NUCLEAR PROJECT NO. 2

AMENDMENT TO FACILITY OPERATING LICENSE

Amendment No. 122  
License No. NPF-21

AMENDMENT NO. 122 TO FACILITY OPERATING LICENSE NO. NPF-21

FIGURE 3.4.6.1.c

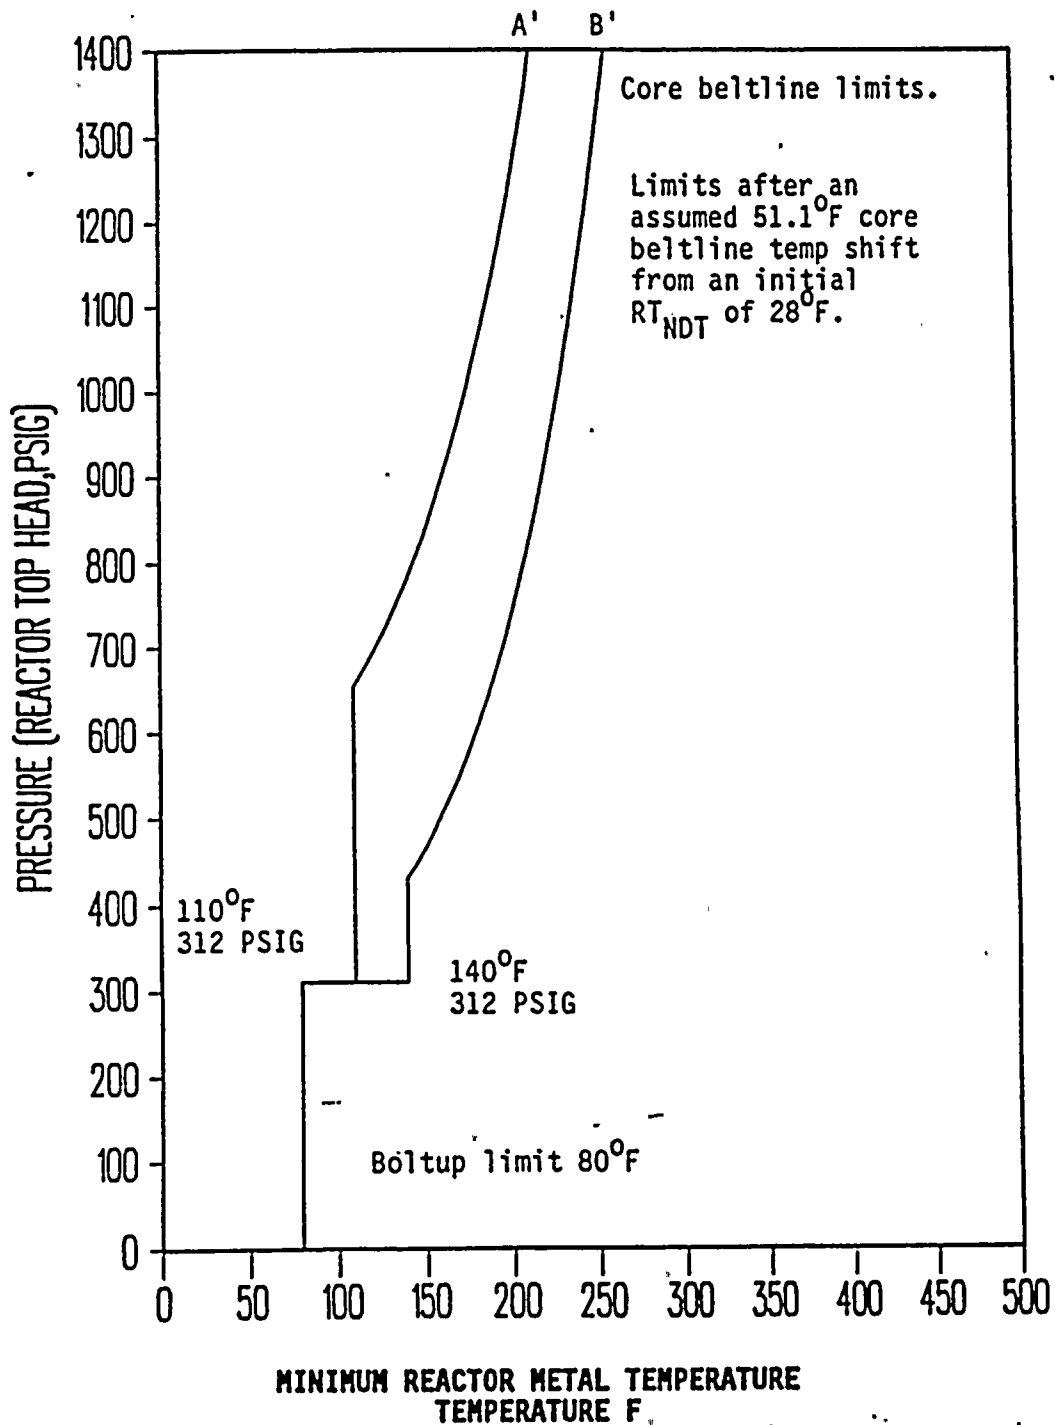
3.4.6.1 The reactor coolant system temperature and pressure shall be limited in accordance with the limit lines shown on Figure 3.4.6.1 or 3.4.6.1.c\* (1) curve A or A' for hydrostatic or leak testing; (2) curve B or B' for heatup by non-nuclear means, cooldown following a nuclear shutdown and low power PHYSICS TESTS; and (3) curve C for operations with a critical core other than low power PHYSICS TESTS, with:

4.4.6.1.1 During system heatup, cooldown, and inservice leak and hydrostatic testing operations, the reactor coolant system temperature and pressure shall be determined to be within the above required heatup and cooldown limits and to the right of the limit lines of Figure 3.4.6.1 or 3.4.6.1.c curves A, A', B, B', or C, as applicable, at least once per 30 minutes.

\*Figure 3.4.6.1.c A' and B' curves are effective for less than or equal to 8 EFPY of operation.
